Pioneer Denim Limited (Garments Division)

Horitola, Shahpur Bazar, Madhabpur, Habiganj

4 January 2024

1. Building Information:

Observation-7: Inconsistencies in as-built drawing. (Gate Building -01)

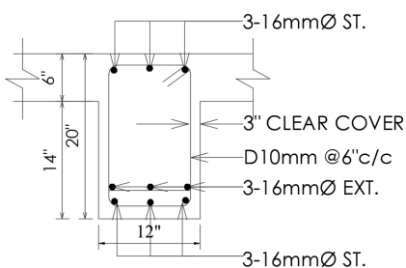
C1 column size found 15"x15" instead of 17"x17"

C2 column size found 20"x20" instead of 22"x22"

The floor beam found 12"d/s instead of 14" d/s.

Description: C1 & C2 column size and floor beam size mentioned in the as-built drawing, does not match with on-site condition. The building engineer is required to survey the whole structure and update the as-built drawing.

Observation-11: Inconsistencies in as-built drawing. (Gate Building -02)

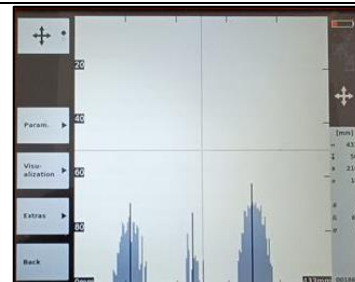
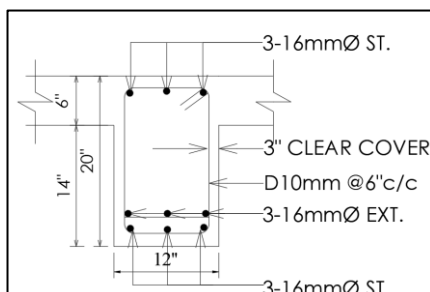
a. C1 column size found 15"x15" instead of 17"x17".
b. 8-nos of rebar found instead of 12 nos

C2 column size found 20"x20" instead of 22"x22"

Floor beam found 10" d/s instead of 14" d/s.

Description: C1 & C2 column size, rebar number and floor beam size mentioned in as-built drawing, did not match with on-site condition. The building engineer is required to survey the whole structure and update the as-built drawing.

Observation 13: Adequacy of steel stairs need to be checked. (Gate Building -02)

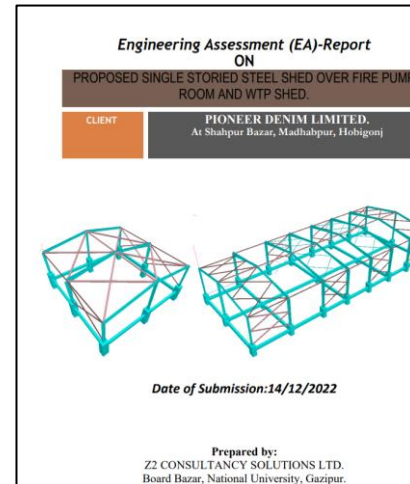
Description: Inadequate structural connection details were found in the steel stairs. Building engineer is required to check the adequacy of the steel stair.

Observation-14: Structure needs to be checked against lateral loading (Fire Hydrant Shed)

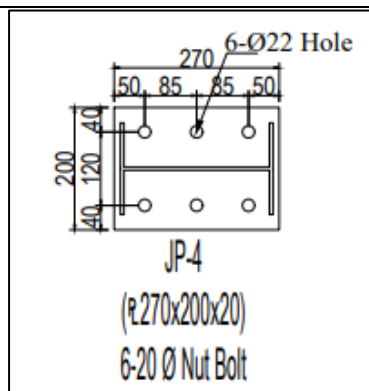
Description: At the time of inspection, a design report was available on site. The building engineer is required to check the structural members against lateral loading and the prepared design report is to be submitted to RSC for review.

Observation-15: Inconsistencies in as-built drawing. (Fire Hydrant Shed)

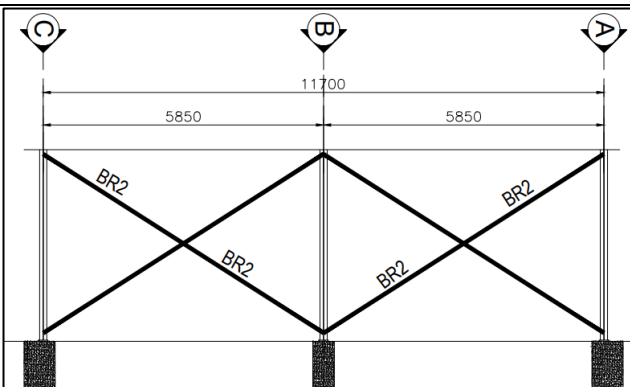
Description: In Joint JP4, 8 nos bolts are found instead of 6 nos and bolt orientation is also different from as-built drawing. The building engineer is required to survey the whole structure and update the as-built drawing.
